Access Compliance Report Public Rights-of-Way (Curb Ramps)

Main Street: SHAKESPEARE_DR Cross Street: ORANGEWOOD_AVE Location: N

ADA ID: RPRK211215130825 Ramp Type: Type 1 - Perpendicular Diagonal Initial Pass/Fail: Pass Overall Compliance: No Severity Score: 2

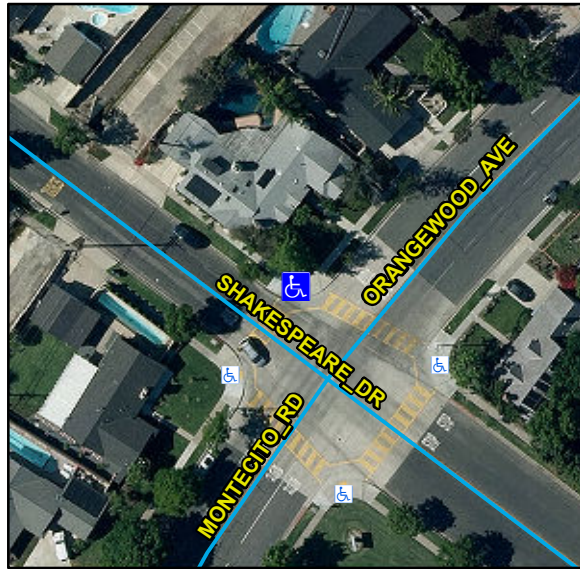
R304.2.2, R304.2.2-Perp, R304.3.2-Para, R304.5.3, STD 1115

Remove & Replace Curb Ramp With Two New Directional Ramps or Equivalent.
